**LEVY COUNTY NUCLEAR POWER PLANT, UNITS 1 AND 2  
DOCKET NOS. 52-029 AND 52-030  
PARTIAL RESPONSE TO REQUEST FOR ADDITIONAL INFORMATION LETTER NO. 034  
RELATED TO BASIC GEOLOGIC AND SEISMIC INFORMATION**

**Levy Nuclear Power Plant Units 1 and 2  
Response to NRC Request for Additional Information Letter No. 034 Related to  
SRP Section 2.5.1 for the Combined License Application, dated May 8, 2009**

Site Vicinity Geologic Map  
 (40-km [25-mi.] and 8-km [5-mi.] Radius)  
 Figure 2.5.1-244 (Revised)

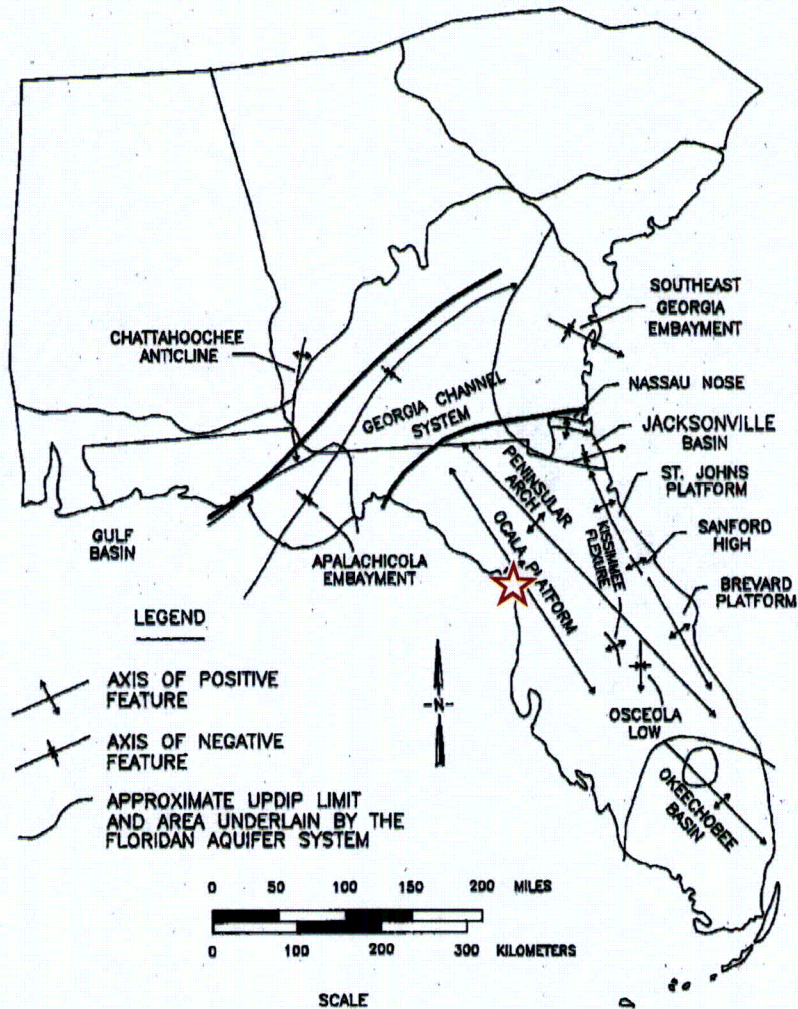
FSAR Section 2.5.1.2.1.1 (pg 2.5-57) states that the site is located in the Limestone Shelf and Hammocks subzone of the Gulf Coastal Lowlands geomorphic province, and indicates that this zone is characterized by a "highly karstic, erosional limestone plain" overlain by Pleistocene marine terrace deposits. This FSAR section refers to an irregular, "highly-solutioned Eocene limestone" in this subzone, but does not specify whether or not this limestone unit is the Avon Park Limestone. The Avon Park is the foundation unit at the site.

In order for the staff to assess information related to the karstic character of the Avon Park Limestone, please indicate in the text whether the unit being briefly described on pg 2.5-57 of FSAR Section 2.5.1.2.1.1 is, in fact, the Avon Park foundation unit.

The Limestone Shelf and Hammocks subzone is primarily underlain by the Ocala Group and to a lesser degree the Avon Park Formation (Figure 2.5.1-244). Karst development is greater in the limestone units of the Ocala Group relative to the more dolomitic Avon Park Formation, which underlies the site. The text will be modified in a future revision to clarify that the both Eocene bedrock units are present and that karst development is not as great in the more dolomitic Avon Park Formation.

Figure 2.5.1-244 will be revised to show locations of springs and well locations (well locations are being added in response to RAI 02.05.01-34).

Figure 2.5.1-244 will be revised to show spring locations that support the revised text outlined below (see Attachment 02.05.01-28A). Figure 2.5.1-244 is also being revised in response to RAI 02.05.01-34 to show well locations.

RAI 02.05.01-15 Figure 1

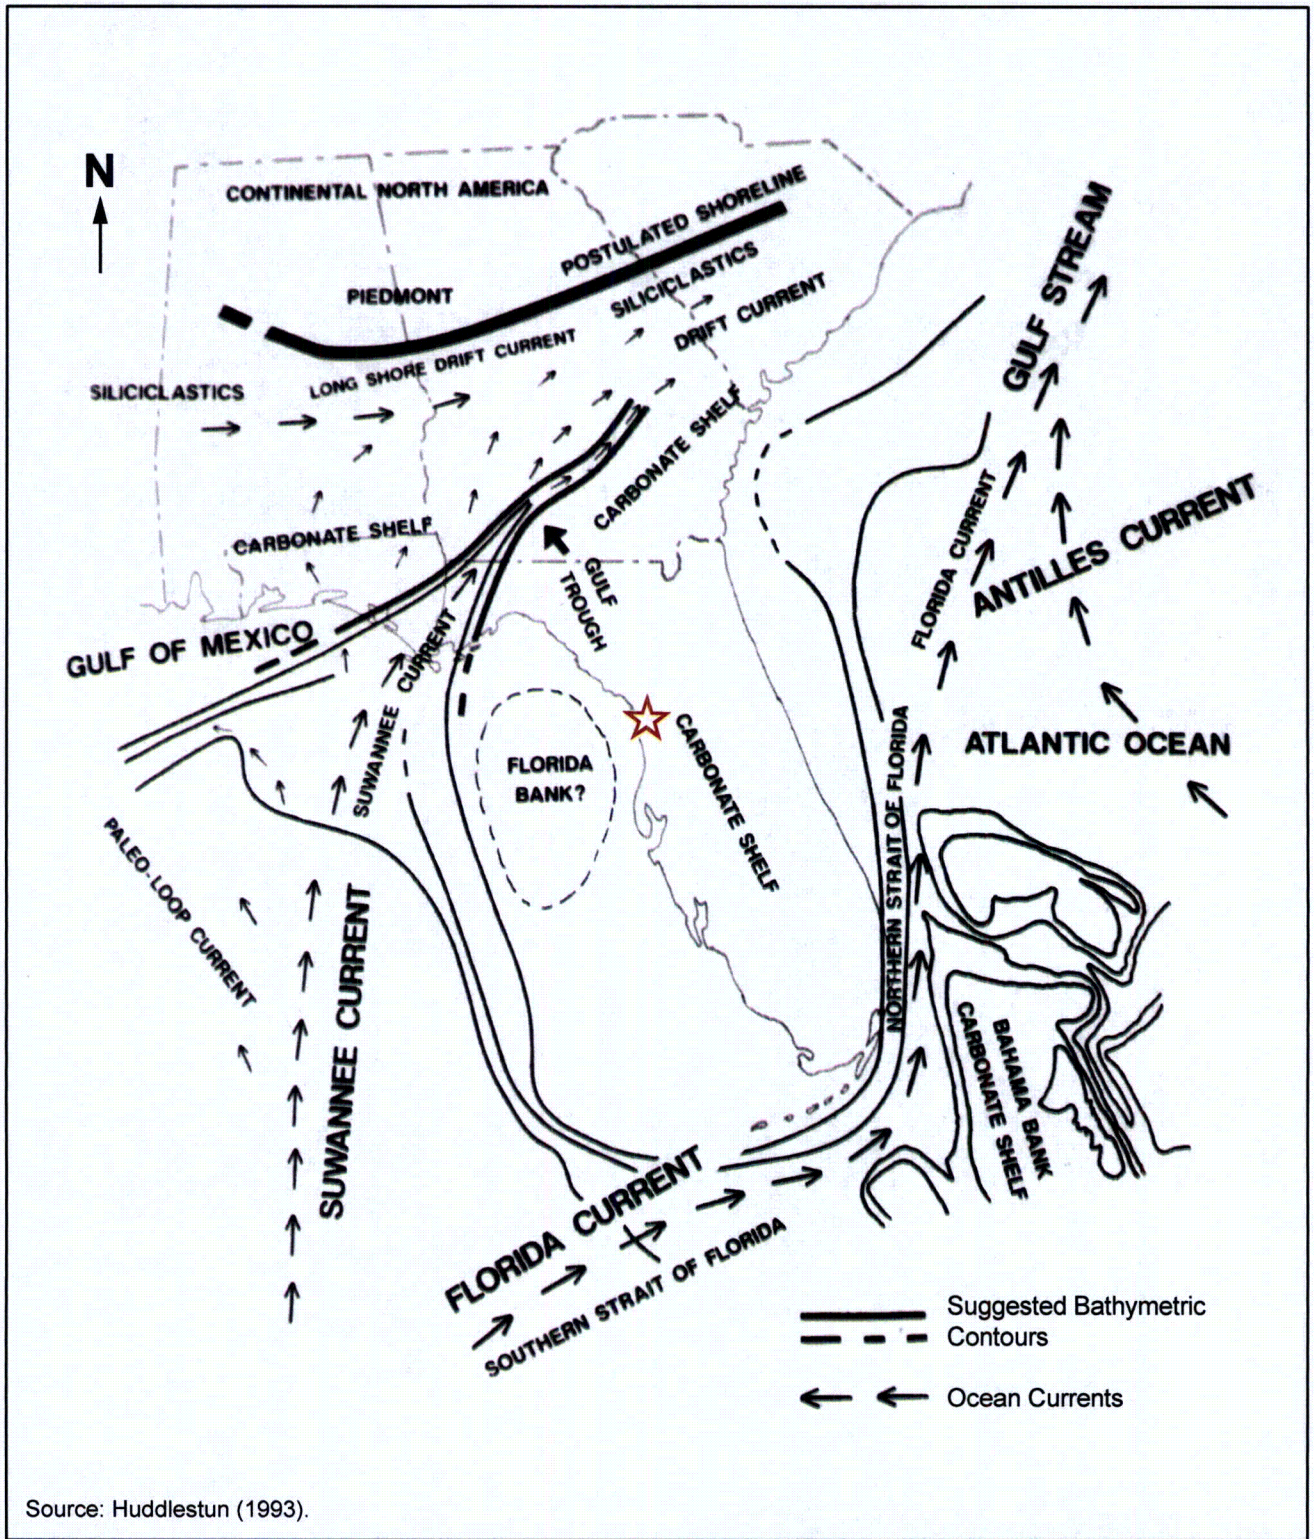
FSAR Section 2.5.1.1.2.3 (pg 2.5-23) discusses changes in the Cenozoic depositional environment for the Florida platform on which the site is located. Tectonic features related to the Georgia Channel system, a system which represents two distinct but related sedimentological regimes of different ages, are located in FSAR Figure 2.5.1-208. However, the Suwannee current is not located on this figure and its pertinence in regard to changing Cenozoic depositional history is unclear.

In order for the staff to assess the depositional history of the Florida platform on which the site is located, please locate and discuss the pertinence of the Suwannee current in regard to changing Cenozoic depositional history.

The Georgia Channel System, which included the Apalachicola Embayment and the Southeast Georgia Embayment, extended across the northern part of the study region (RAI 02.05.01-15 Figure 1). RAI 02.05.01-15 Figure 2 shows the location of the Suwannee Current relative to the Gulf Trough as defined by Huddlestun (Reference RAI 02.05.01-15 01). (see also the Response to RAI 02.05.01-18 for revised figures showing tectonic and structural features in the study region).

Regional Physiographic Map  
(320-km [200-mi.] Radius)  
Figure 2.5.1-201 (Revised)

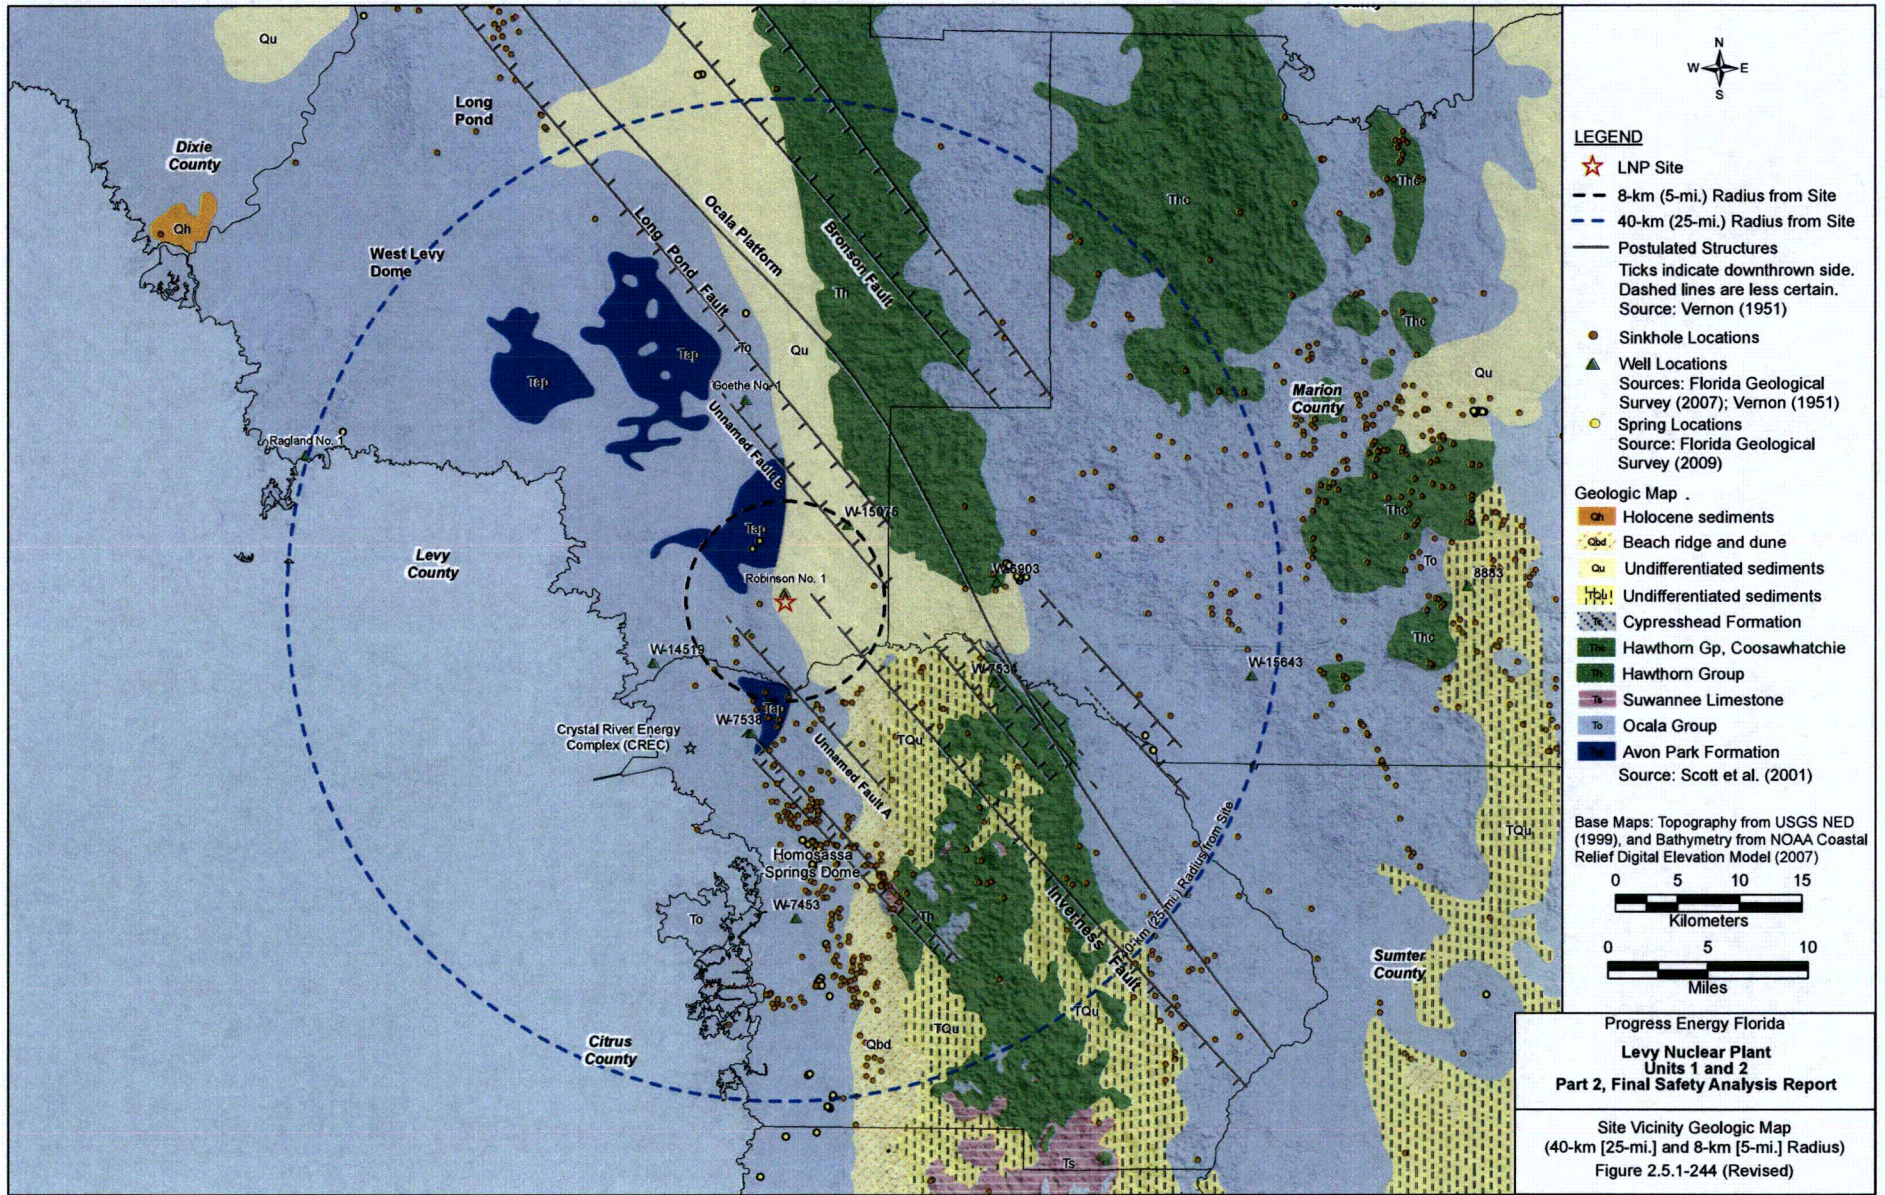
FSAR Section 2.5.1.2.1 (pg 2.5-55), on site physiography, states that county lines are shown for Levy, Citrus, and Marion Counties on Figure 2.5.1-201. However, no county boundaries are illustrated on that figure.

In order for the staff to locate these three counties in relation to physiography of the site, please include county lines on Figure 2.5.1-201 or cite the figure where they are shown.

FSAR Section 2.5.1.2.1 (pg 2.5-55), on site physiography, states that the site lies within the Gulf Coastal Lowlands geomorphic province and cites Figure 2.5.1-233. FSAR Section 2.5.1.1.1.1 (pg 2.5- 15) on regional physiography indicates that the site is located within the Floridian section of the Coastal Plain physiographic province and cites Figure 2.5.1-201. Neither of these two figures illustrates how the geomorphic and physiographic provinces are related to enable a clear distinction between regional and site-scale physiography, geomorphology, and topography. In addition, the Gulf Coastal Lowlands province is referred to as a "physiographic" province in FSAR Section 2.5.1.2.1.3 (pg 2.5-60) rather than a geomorphic province, leading to further blurring of any pertinent distinctions, if they exist.

In order for the staff to clearly understand the relationship between regional and site-scale physiographic provinces and their characteristic geomorphology and topography, please include all physiographic and geomorphic province boundaries on one or both of the figures cited. Please also refer to the Gulf Coastal Lowlands province correctly in the text in regards to representing it as a geomorphic province.

Figure 2.5.1-201 provides a regional perspective on physiographic provinces. County lines are not appropriate at the scale of the map. The Central Highlands geomorphic province is shown on revised Figure 2.5.1-201 (see Attachment 02.05.01-25A) for cross reference to the more detailed Figures 2.5.1-233 and 2.5.1-234 showing the county lines with respect to local geomorphic units. The paragraph in FSAR Section 2.5.1.2.1 that states that Levy, Citrus, and Marion Counties lie within the site vicinity, and that these three counties lie within the central (midpeninsular) physiographic zone will be modified in a future amendment to delete reference to the counties with respect to Figure 2.5.1-201.

Figure 2.5.1-201 will be revised as follows: Legend will be revised for clarification.

Figure 2.5.1-201 shows the location of the site with respect to the regional physiographic provinces (Reference 2.5.1-209) (i.e., the three sections of the Coastal Plain Province), the state of Florida transpeninsular physiographic divisions (Reference 2.5.1-212) and the Central Highlands geomorphic province (Reference 2.5.1-216), thus illustrating the relationship between the physiographic and geomorphic provinces. For clarification, the legend of Figure 2.5.1-201 (see Attachment 02.05.01-25A) will be modified in a future revision to include the Central Highlands under the heading geomorphic provinces. Additionally, the text will be modified in a future revision to refer to both the Central Highlands and Gulf Coastal Lowlands correctly as geomorphic provinces.

Figure 2.5.1-201: Legend will be modified to include the Central Highlands under the heading geomorphic provinces.
